<b>Tender Questions and Answers</b>	<b>Document Identifier</b> 240-7124948	<b>Rev</b> 1
		<b>Effective Date</b> 01 April 2023	
		<b>Review Date</b> April 2026

<b>Request for Enquiry Number</b>	<b>WCKBG2516SB</b>
<b>Description / Project Title</b>	<b>THE SUPPLY AND REPLACEMENT OF THE INVERTERS AND AUXILIARY SYSTEM AT KOEBERG OPERATING UNIT (KOU)</b>
<b>Tender Questions Closing Date</b>	<b>30 April 2024</b>

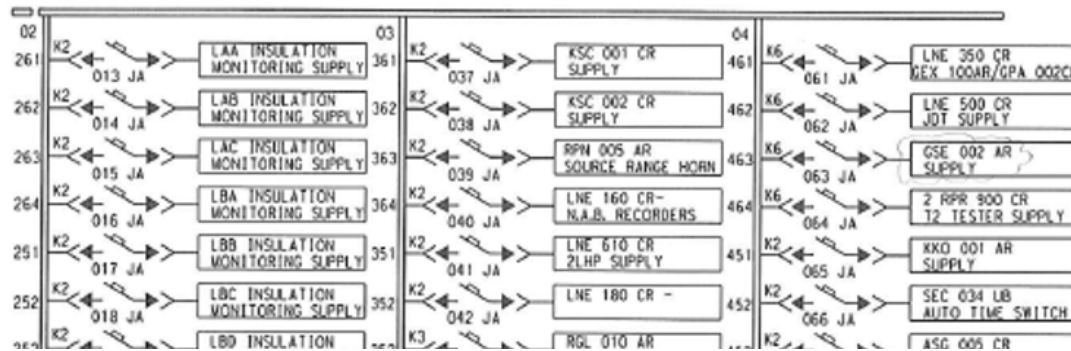
No.	Document	Section	Page	Requirement	Questions	Answers
29.					In the document provided by Eskom, Rev4_Q27_Item 7_Single Line Diagram, there is the single line drawing but the breakers capacity is not referenced, see below. Can you specify the output breakers capacities?	Breaker capacities are K1, K2.. ect. See KBA1217LOO052 (PDF page 49) supplied previously also found attached "Rev 5_Q29_Item 1_Feeders – info"
30.					We do not find, in the attached documents, the single line diagrams of 0LZC 001 and 6SSC/D, could you please send them?	0LZC single line diagram can be found on page 64 of "Rev 3_Q18_Item 2_OLZC - info.pdf" breaker size for 0LZC can be determined from the text of the same document. 6SSC/D docs can be collected from Koeberg. See 26
31.					Cable entry for each switchboard is also necessary: LNE 001/2/3, 9LNF/G/H , 0LZC 001 , 6SSC/D	See TRS table 4
